Ventura County Cultural Heritage Board Agenda

Oxnard Cultural Heritage Board Staff Report and Recommendations Agenda of May 09, 2016 – Item No. 4

On behalf of the Owner, the applicant requests approval of a Certificate of Appropriateness (COA) for the following alterations: a) after-the-fact demolition and rebuild of the 280 square feet (s.f.) original detached single-car garage; b) relocation of said rebuilt garage; c) after-the-fact re-siding of an existing guest house; d) proposed construction of a new detached single-car garage of 252 s.f.; e) new driveway from alley using Grasscrete paving system; f) installation of a six-foot high ornate wrought iron railing at the front of house and a wrought iron railing and solid iron paneled gates at the alleyway; and g) partial demolition of a rear deck. Case No. COA#15-683-02

444 South F Street, in Oxnard, CA. APN: 202-0-075-090

Photo No. 2 – 2015 main house front view

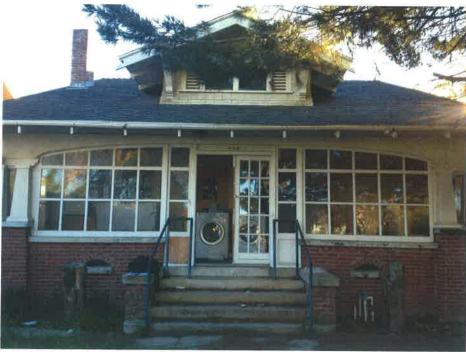
The recently installed ornate style wrought iron fencing along the front of the house without Board approval appears inconsistent with the simple bungalow style of the residence. The Board may wish to place a condition on the COA to require the removal of the chain-link fencing along the front of the property in order to authorize the existing ornate wrought iron fencing in its current location. With adherence to the proposed condition of approval, these Standards would be met.

SITE PLAN

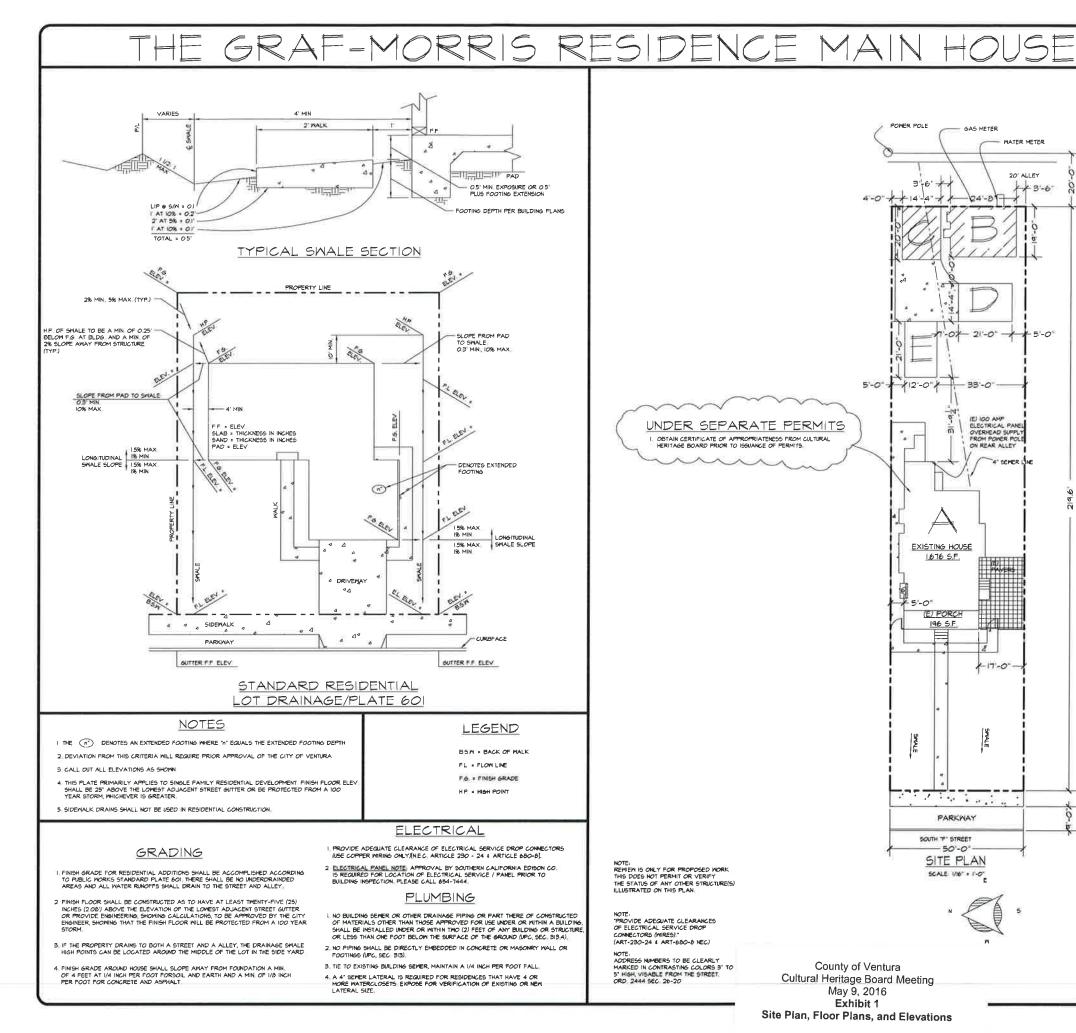
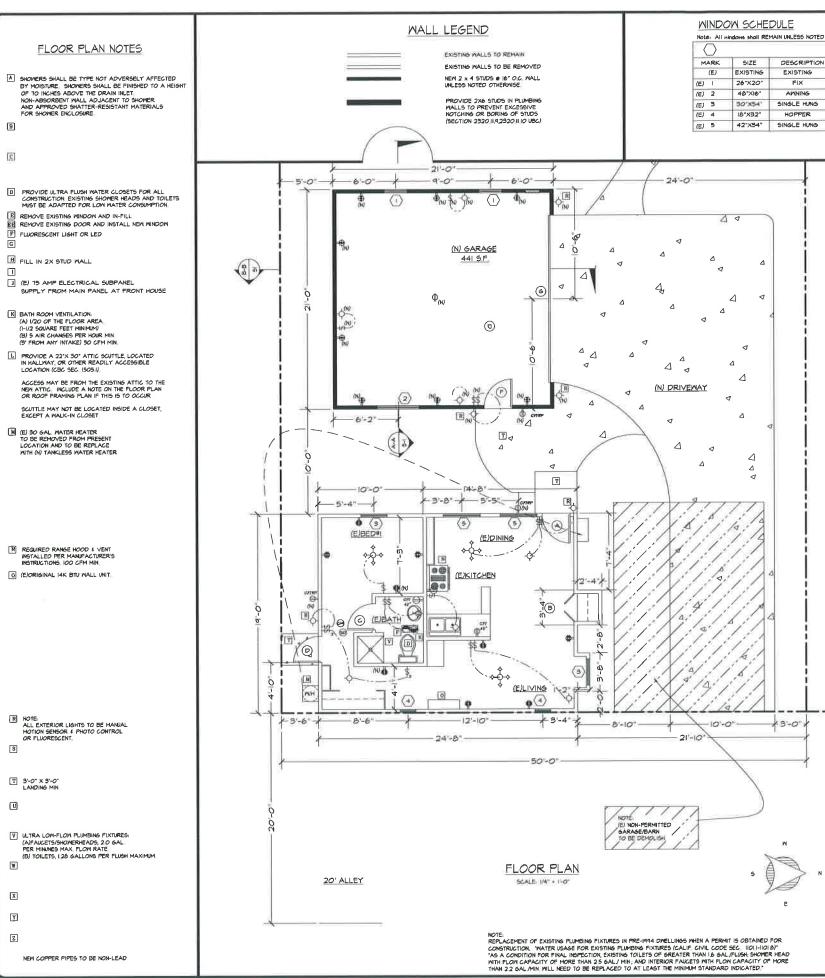
Rebuilt Garage: Because the original garage was essentially demolished and rebuilt in place, the rebuilt garage has lost its non-conforming status and must be relocated to allow access to an additional garage to meet City Zoning Code requirements. The proposed garage and relocated garage will be setback a distance of thirty feet from the alleyway. Existing garages in the District are generally between two and ten feet

from the rear property line. The relocation of the garages would alter the spaces between the detached accessory buildings to the alleyway. This Standard has <u>not</u> been met.

New and Rebuilt Garages: The way in which a new garage relates to other historic buildings of a property is important in historic districts. Staff recommends that the Board consider a condition of approval be placed on the COA to require that the new and rebuilt garages approximate the original configuration, form, massing, style, and detail of the former garage. With adherence to the proposed condition of approval, these Standards would be met.
